STAFF RECOMMENDATION

1204 Russell Street

July 21, 2021

Application: Addition—Violation; Demolition—Show Cause

HISTORICAL COMMISSION PERMIT - 2021026159

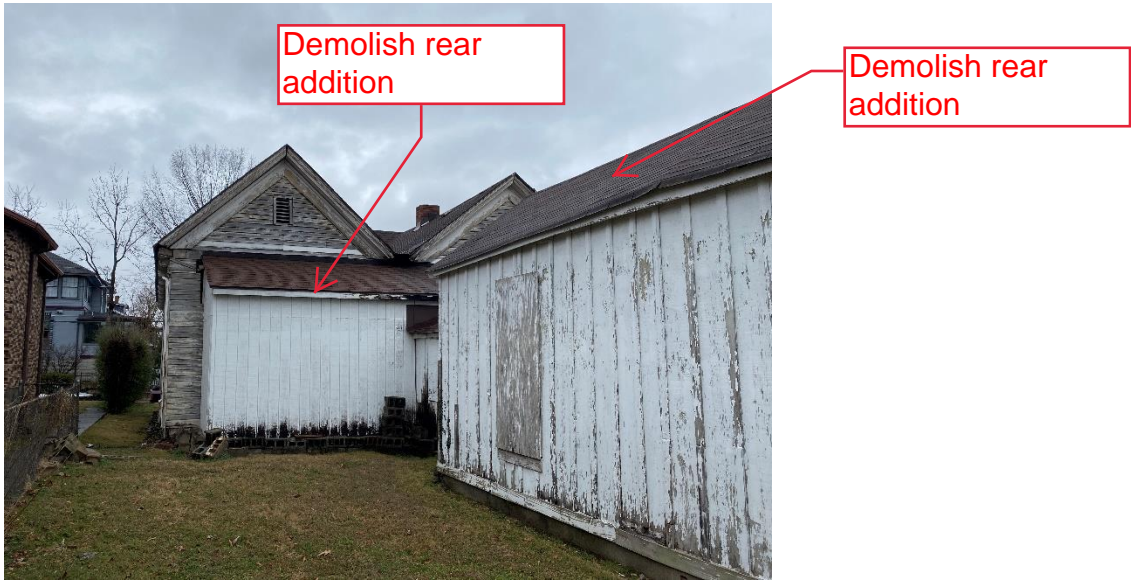
Purpose: Demolish existing rear addition. Repair/replace foundation, siding, roofing, and windows. No alterations to building dimensions, roofshape, or window or door locations or sizes permitted. Demolition of historic house is not permitted.

- Addition to be demolished in accordance with attached site plan.
- All demolition debris to be removed from the site.
- No debris to be buried or burned on site.

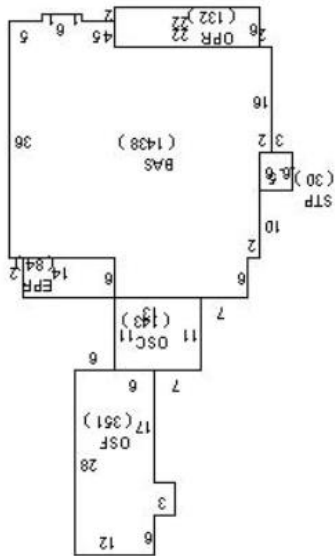
No changes to dimensions of historic house including height or roof pitch approved with this permit.

No changes to window or door openings approved with this permit.

Demolish rear addition only.
